Planning Board – Monday, January 28, 2019, 6:30PM
City Hall Council Chambers – 3 Washington Street, 2nd floor

SPR-08-16 MODIFICATION #1 – 31 WASHINGTON STREET AND 41 SPRING STREET – SITE PLAN – WASHINGTON PARK APARTMENTS

SITE PLAN
WASHINGTON PARK
MULTIFAMILY HOUSING

**GRADING PLAN
WASHINGTON PARK
MULTIFAMILY HOUSING**
LOCATED AT:
**17 WASHINGTON STREET
KEENE, NEW HAMPSHIRE**

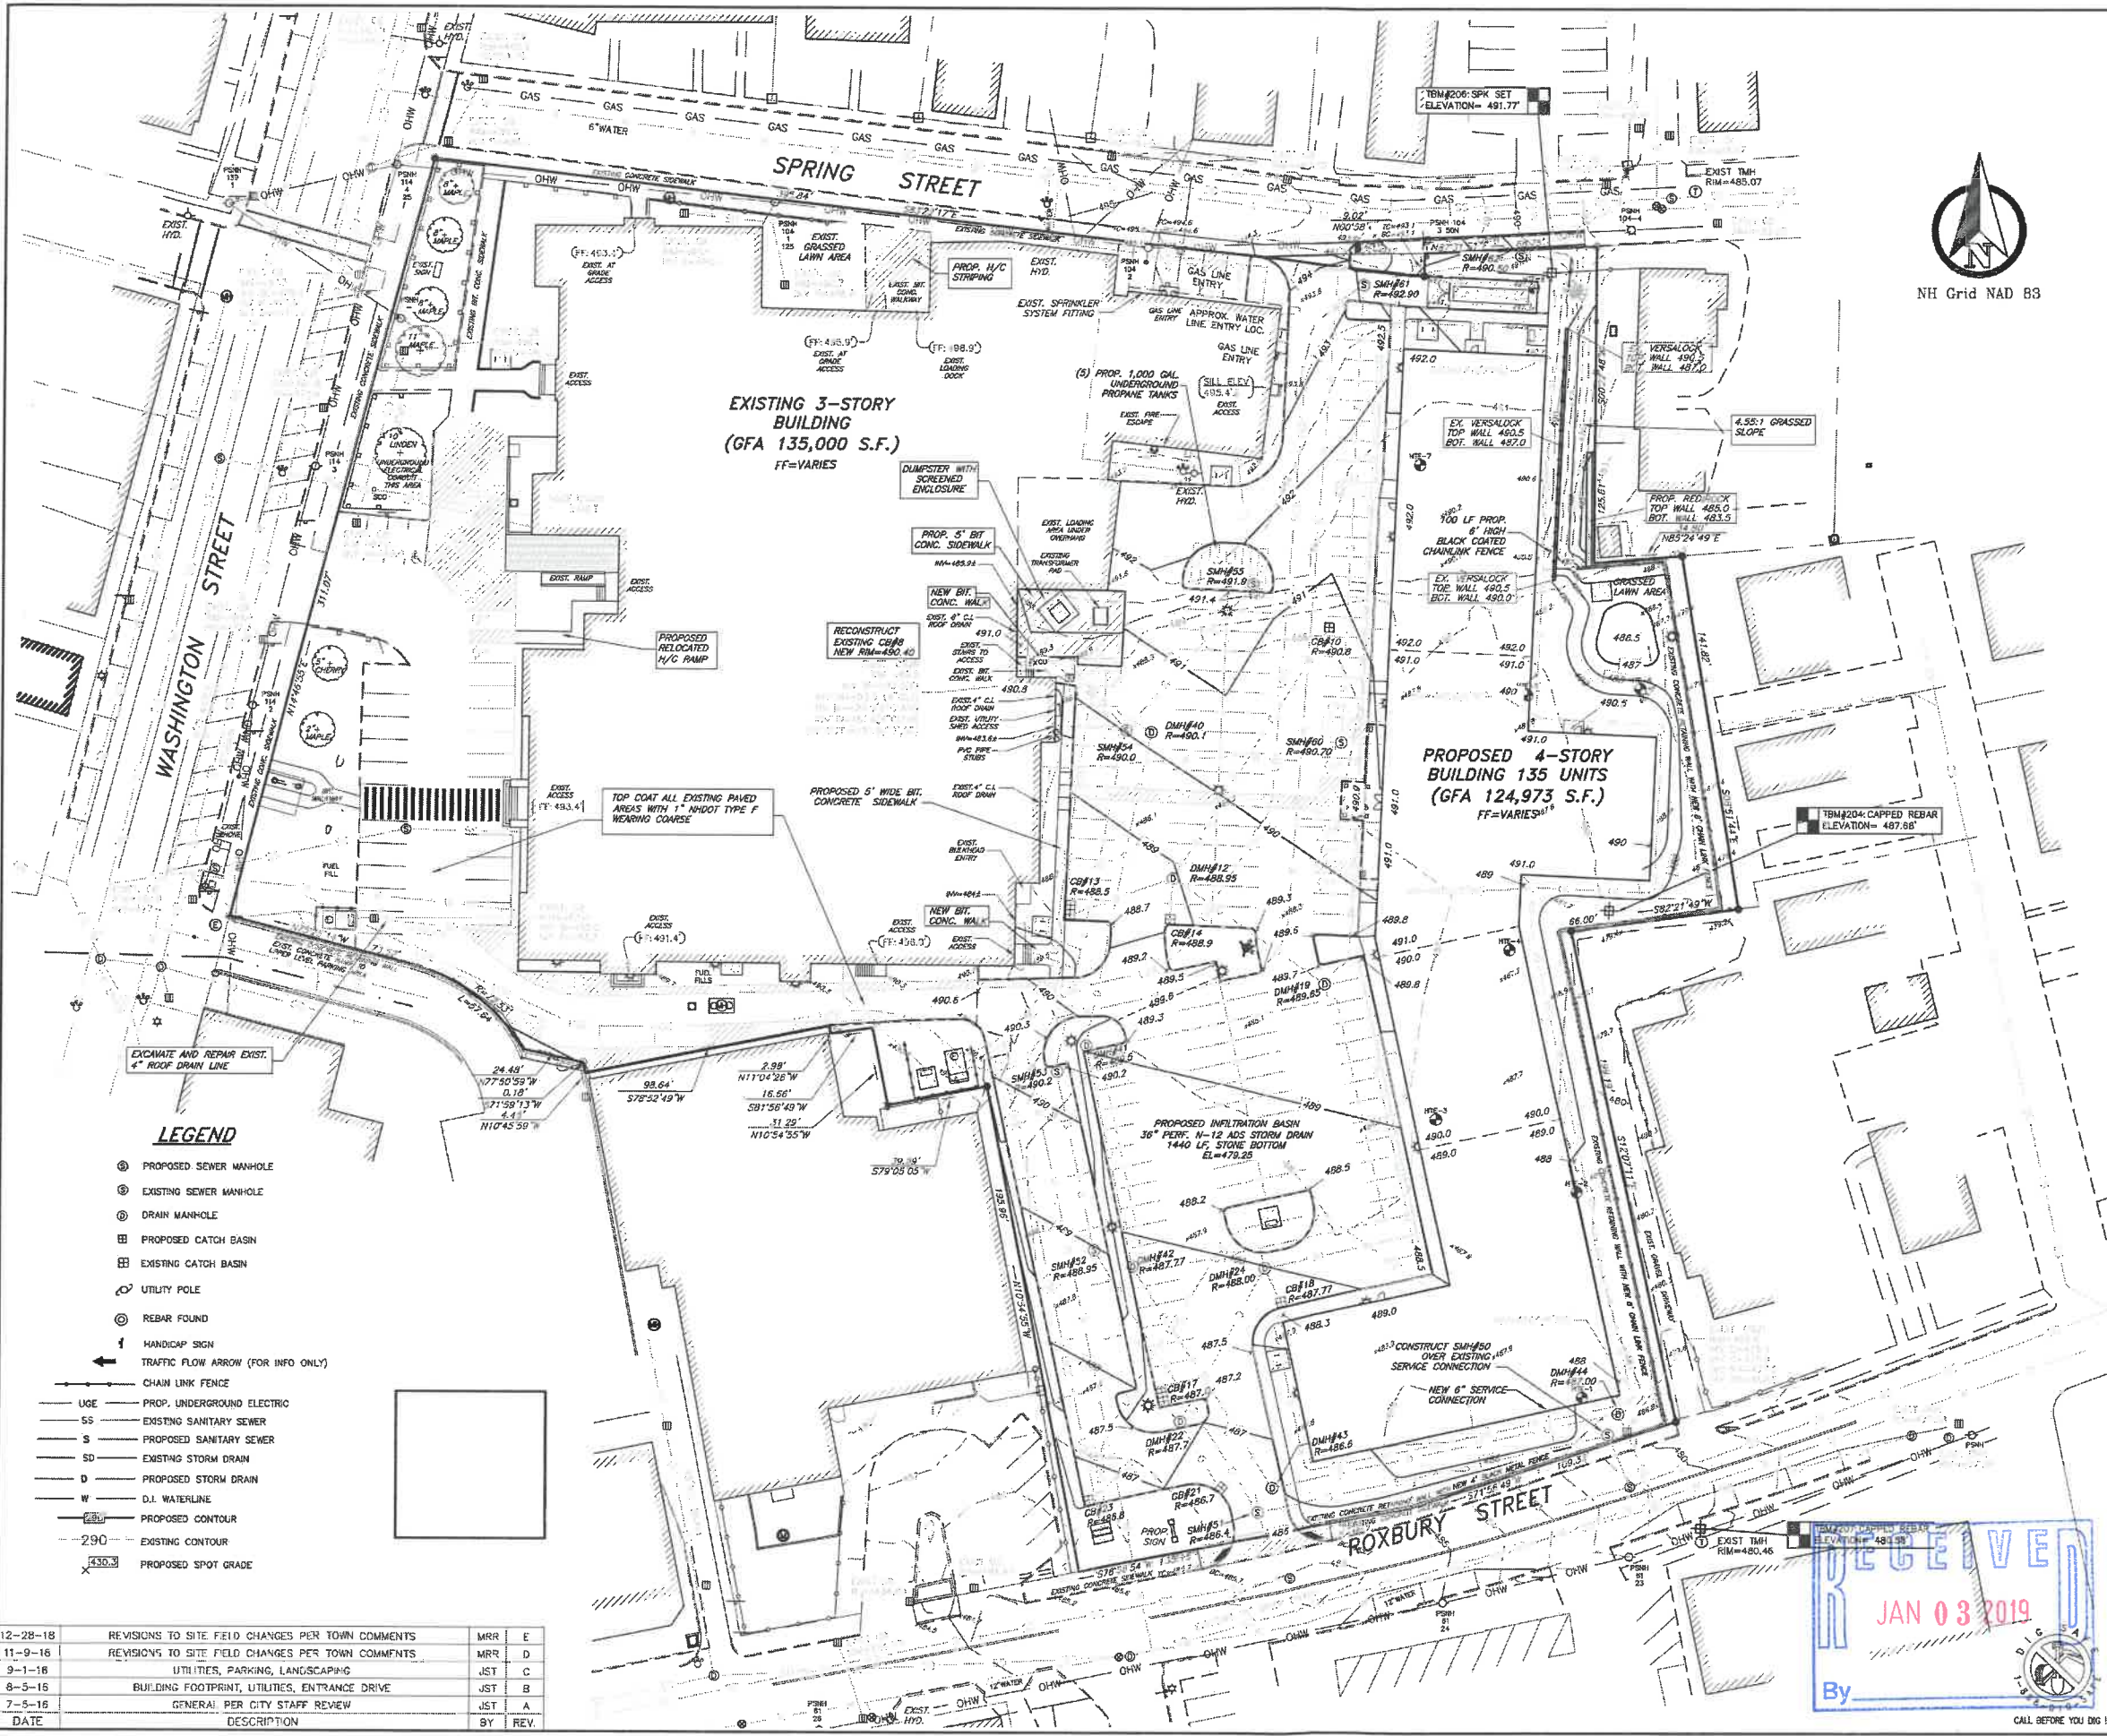
10. The designer's letter should be stamped by a New Hampshire licensed professional engineer.
11. The proposed grading around the Versa-Loc® wall is unclear. The top of the wall is at elevation 490.5. The 490 contour line connects to the wall, implying that the ground surface is 6" lower behind the wall. Please clarify how this area will drain.

12. The proposed grading in vicinity of the dumpster pad is unclear. It appears that all runoff from the area of the entrance and dumpster pad will be channelized and discharged in the northwest corner of the adjacent property. This is not permissible. Please clarify.

14. The intent of the depression near the generator pad is unclear. If this area is intended to infiltrate Stormwater, please clarify how overflow will be handled.

15. A note on Sheet 5 indicates that the paved area south of the historic Middle School is to be overlaid with 1" wearing coarse. In actuality, original pavement in this area was removed and replaced entirely. Please provide original and final spot elevations in this area.
